ASBESTOS ABATEMENT OF BUILDING 1 IOWA CITY, IA

PROJECT NO.
113267-0

ISSUED FOR
ADD 1

SD-1

BUILDING 1 - TENTH FLOOR PLAN - 10E222

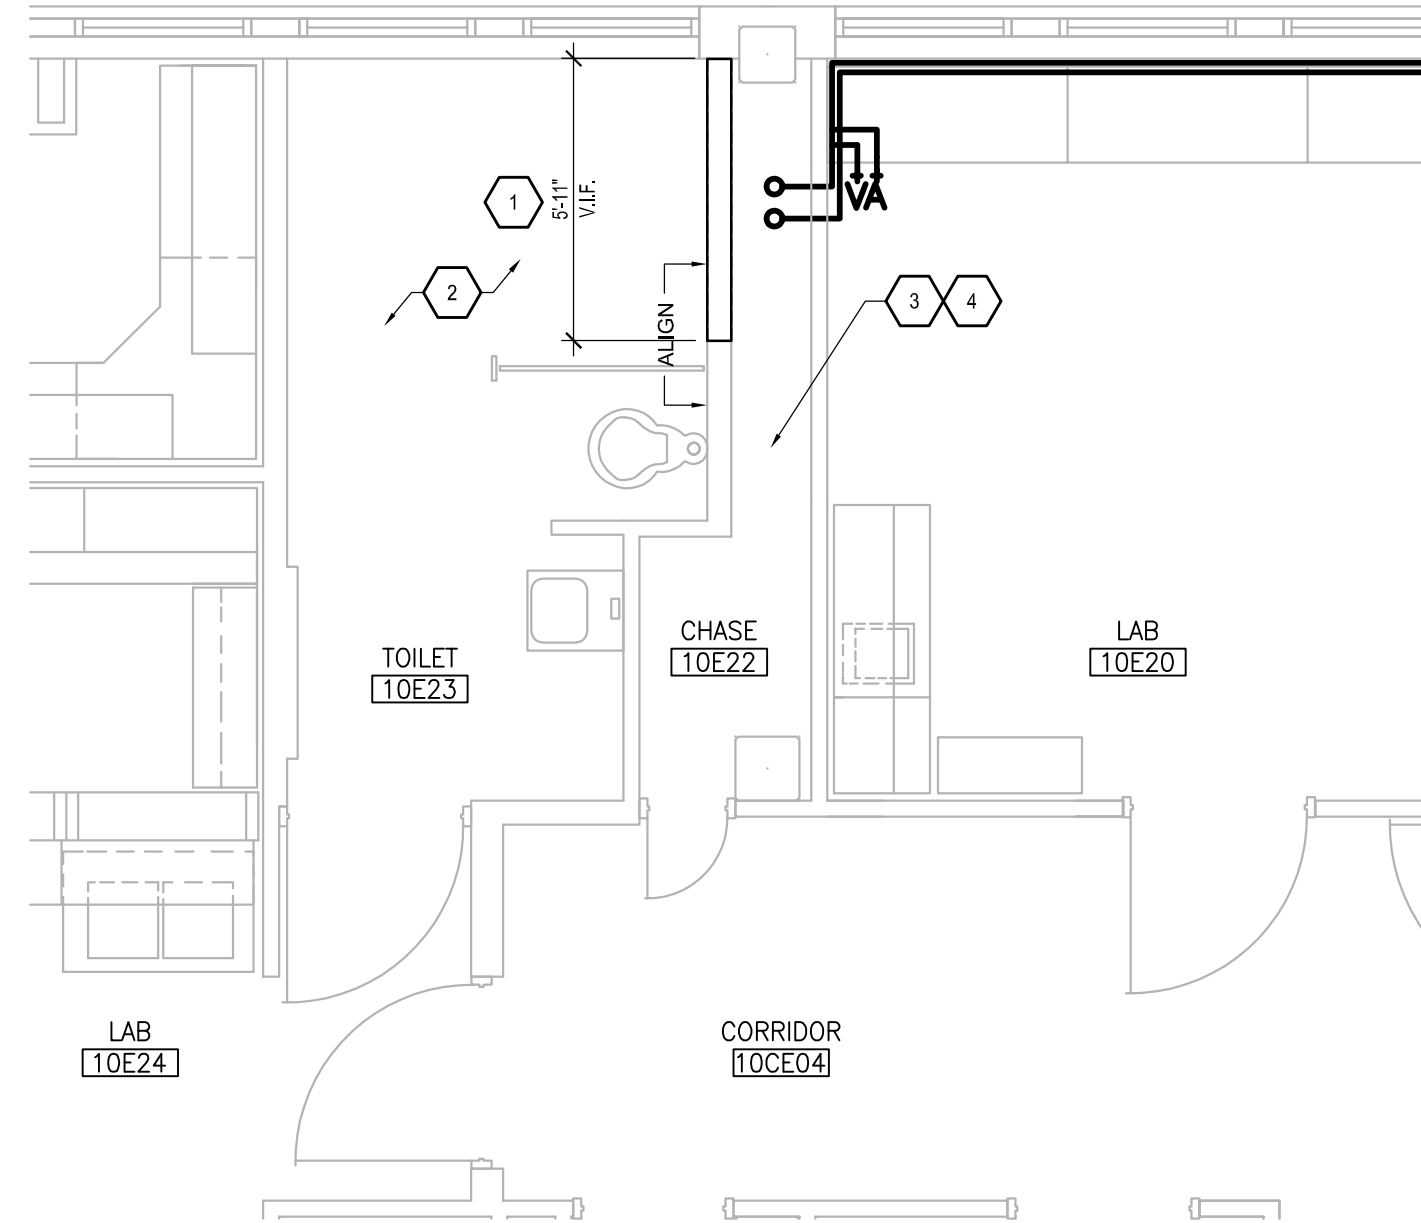
10E22 KEYED NOTES

1. REMOVE PORTION OF WALL INDICATED FROM TOP OF SLAB TO BOTTOM OF STRUCTURE. FOLLOWING ABATEMENT CONSTRUCT NEW WALL OF 5/8" GYPSUM BOARD OVER METAL STUDS. ALIGN FINISHED FACES.
2. REMOVE PLASTER AS NECESSARY TO COMPLETE WALL DEMOLITION AND CONSTRUCTION. PATCH BACK FOLLOWING CONSTRUCTION AND PAINT TO MATCH EXISTING. REPLACE ALL CEILING MOUNTED ITEMS AFFECTED BY CEILING REMOVAL.
3. REMOVE AND DISPOSE OF ASBESTOS-CONTAINING TSI LOCATED IN WALK-IN CHASE.
4. CONTRACTOR SHALL RE-INSULATE EXISTING PIPING AND DUCTWORK WITHIN THIS AREA AFTER ASBESTOS ABATEMENT WORK IS COMPLETED. REFER TO SPEC SECTIONS 22 07 11 AND 23 07 11 FOR INSULATION REQUIREMENTS. REFER TO THE LIST WITHIN THE AREA FOR TYPE OF SYSTEM & APPROXIMATE SIZES & LENGTHS OF PIPE/DUCT TO BE RE-INSULATED WITHIN THE AREA (CONTRACTOR TO FIELD VERIFY SYSTEM, SIZE & LENGTHS PRIOR TO RE-INSULATING).
